Full Planning Application [P/FUL/2021/01018](#)

Install ground-mounted solar panel photovoltaic solar arrays, substation, inverter and transformer units, security fencing, gates and CCTV; form vehicular access, internal access track, landscaping and other ancillary infrastructure.

COMMENTS - PROPOSED CHANGES TO THE NDF SOLAR PLANNING APPLICATION

Save Hardy's Vale responses to the [Agent's letter to the Case Officer](#) (24/9/ 2021 15:29)

Image 4 - The E.A. Flood Zones 2 and 3 – Proposed Temporary Construction Compound

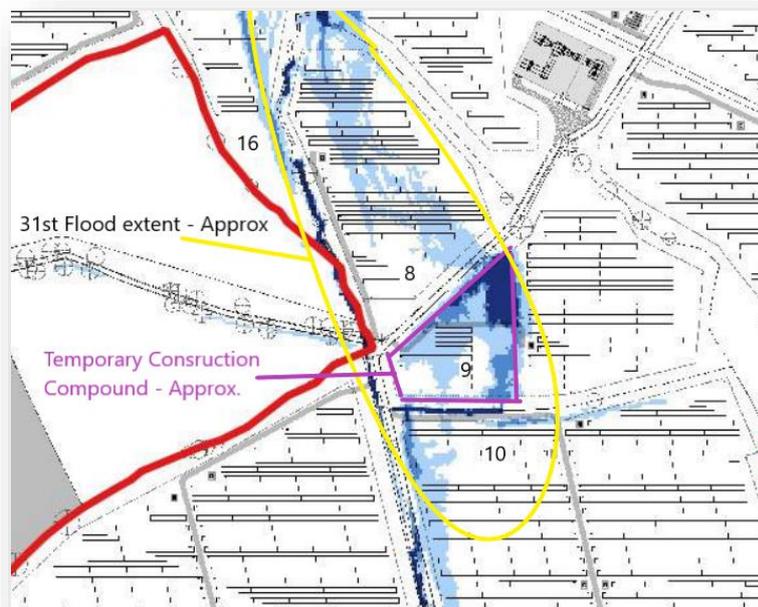
38. A serious issue has come to light as a result of the intense rain events and flooding that happened on the 29th, 30 and 31st October, when some 86.3mm of rain fell during the three days. On Saturday 30th, 38.6 mm of rain was recorded between 03:00 to 12:00. Along with local access roads becoming impassable, extensive fluvial and pluvial flooding covered the land selected for the Temporary Construction Compound. While we do not have precise flow rates and flood depths, it is clear in the image that the site chosen for parking and unloading HG deliveries was extensively flooded.

39. While the Applicants FRA notes that: “the EA’s JFLOW model commonly overestimates fluvial flood extents” (this is not the informed view of the local residents) the flooding shown in the image is evidence that, on this occasion, the EA mapping (Image 9) significantly **underestimated** the extent of actual Zone 2 and 3 flooding.

40. Paragraph 4.45 of the FRA notes that: “Good construction practices will be undertaken to ensure that no adverse impacts on surface water or groundwater quality occur during the construction phase.” The fact that the selected area for the compound could be under water would make that difficult to achieve.
